280 Manse Road - Official Plan Amendment, Zoning Amendment, Subdivision Applications - Request for Direction Report

Date:	April 9, 2015
To:	Scarborough Community Council
From:	Acting Director, Community Planning, Scarborough District
Wards:	Ward 44 – Scarborough East
Reference Number:	14 101641 ESC 44 OZ and 14 101644 ESC 44 SB

Attachment 1: Site Plan

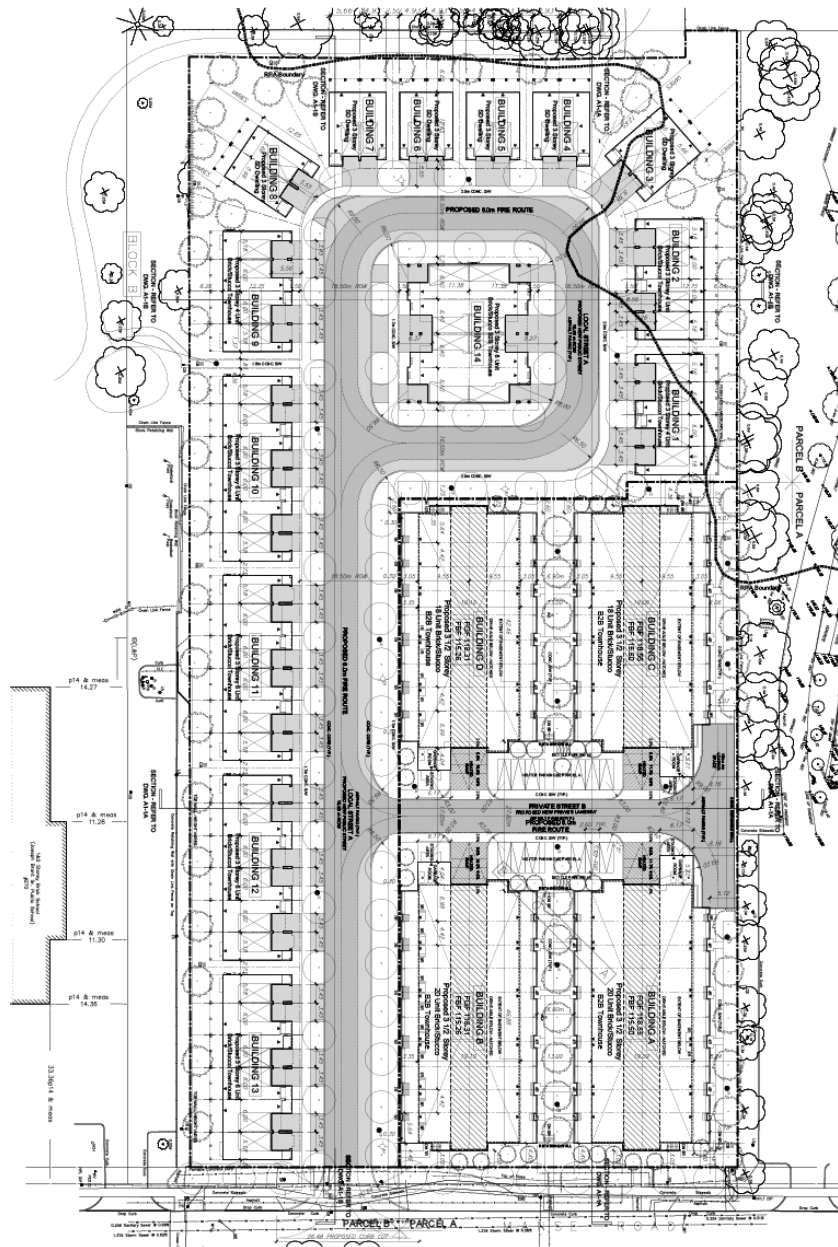
Urban Forestry staff in the Ravine and Natural Feature Protection group has requested that proposed Buildings 1, 2, 3 and C be setback from the Natural Heritage System, from the trees and their associated tree protection zones within the area regulated by the RNFP By-law, and from the trees and their associated tree protection zones within the adjacent City parkland.

The flankage yard building setback for the freehold street townhouse adjacent to Manse Road should be increased from 1.36 metres, to a minimum of 3 metres. This would allow the side wall of the building to be setback consistent with the building setbacks of the common element back-to-back units along Manse Road and provide for an adequate landscaped area along Manse Road.

The proposed 1.5 metre front wall building setback, in combination with the proposed 3.45 metre wide private driveway, results in very limited front yard landscaping opportunities. Where parking is at the front of a townhouse, the guidelines state that a minimum 6 metre building setback be provided. Currently a 5.56 metre building setback to the garage wall is proposed. This setback poses a safety concern as this does not afford sufficient length to park a car without overhanging the public sidewalk. Transportation Services staff recommend a 0.3 metre minimum setback from the edge of

a parked vehicle to the public sidewalk. To achieve this objective a minimum setback of 5.9 metres to the property line would be required.

The maximum driveway width identified in the guidelines is 3.0 metres. Reducing driveway widths from 3.45 metres (as currently proposed), to 3.0 metres when paired with adjacent driveways (as is proposed), will result in an increased amount of soil volume and soft landscaping opportunities. Further, reducing the width of driveways would also result in 6.0 metre wide gaps between driveway pairs (whereas 5.10 metres are currently proposed), which would provide a sufficient width for short-term on-street visitor parking on the proposed public street.

the City's RNFP By-law, staff recommends that the north-west area of the subject lands containing the woodlot, be retained as open space and a pedestrian walkway be added along the south edge of the protected area. This would also enable a pedestrian connection from the existing TDSB owned walkway which extends to Homestead Road in the west, to the future public sidewalk on Street "A". The proposed walkway connecting the south side of Street "A" with the adjacent Joseph Brant Public School is not recommended by staff, and is too narrow (1.5 metres) to meet City specifications.

Transportation Services staff have requested a 6 metre day lighting triangle at the intersection of Street "A" with Manse Road, and 5 metre day lighting triangles at the proposed intersection of Street "A" with the private driveway that will serve as the access point for all vehicular traffic for the proposed back to back common element townhouses. The draft plan of subdivision should also be revised to illustrate a required 0.4 metre road widening along Manse Road.

The proposed transition in right-of-way width from 18.5 metres to 16.5 metres for proposed Street "A" is of concern to Engineering and Construction Services staff from the standpoint of underground servicing. The applicant will need to demonstrate to the satisfaction of Engineering and Construction Services staff that the location of underground servicing will be able to be satisfactorily accommodated.

Attachment 2: Proposed Draft Plan of Subdivision

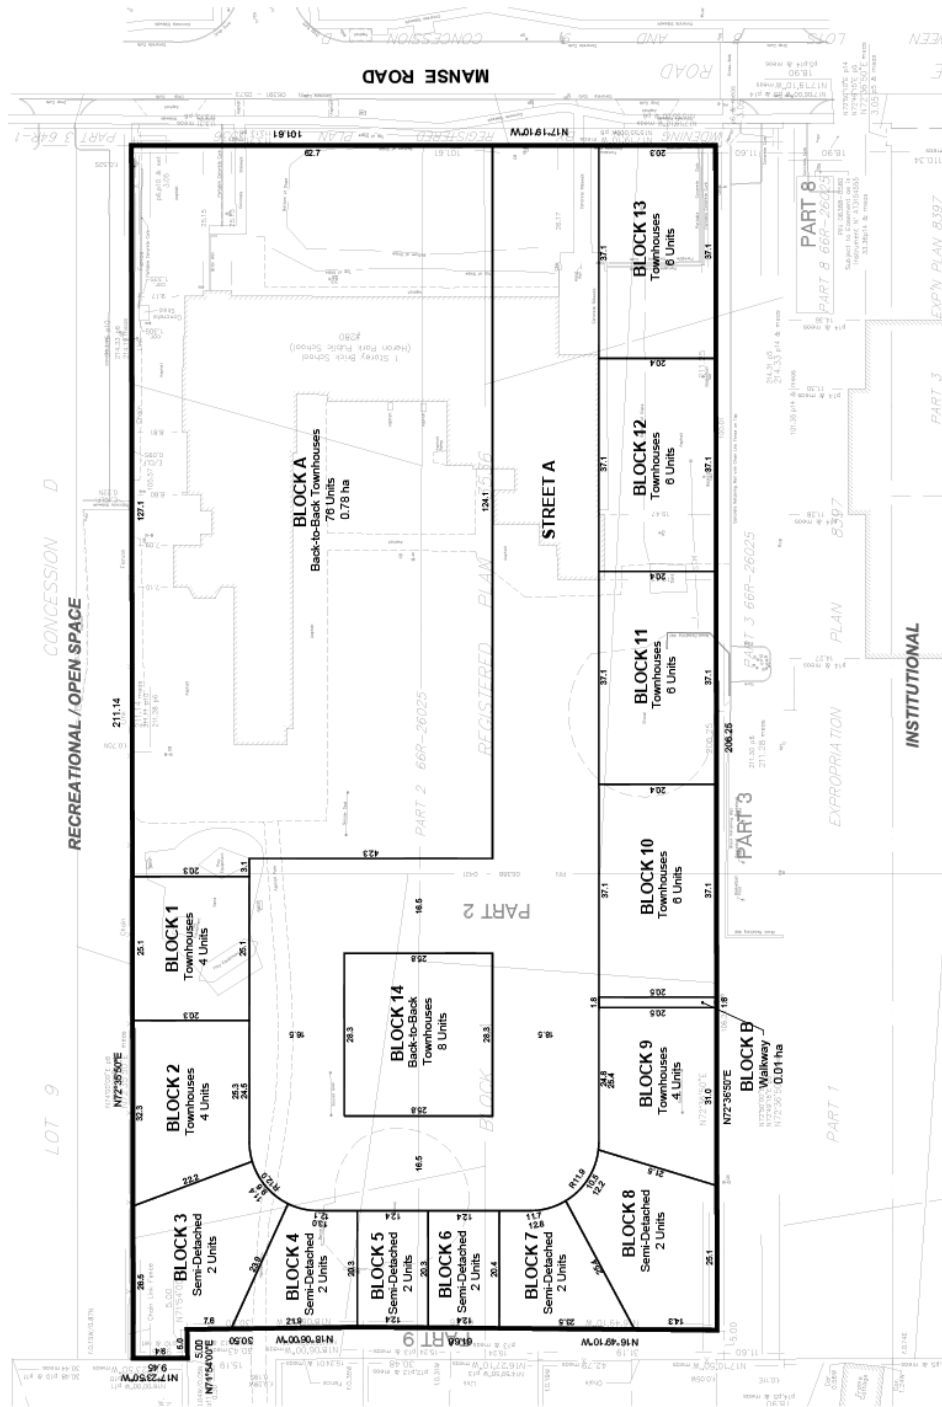
The proposed lot depths for the freehold street townhouses and semi-detached dwellings of approximately 20 metres are shallower than typical freehold lot depths, which are generally 24 metres or more in depth and in combination with minimum front main wall building setbacks of 1.5 metres pose concerns. If the front yard main wall building setback cannot be accommodated at 3 metres in the context of the proposed lot depths, then the depth of lots should be increased.
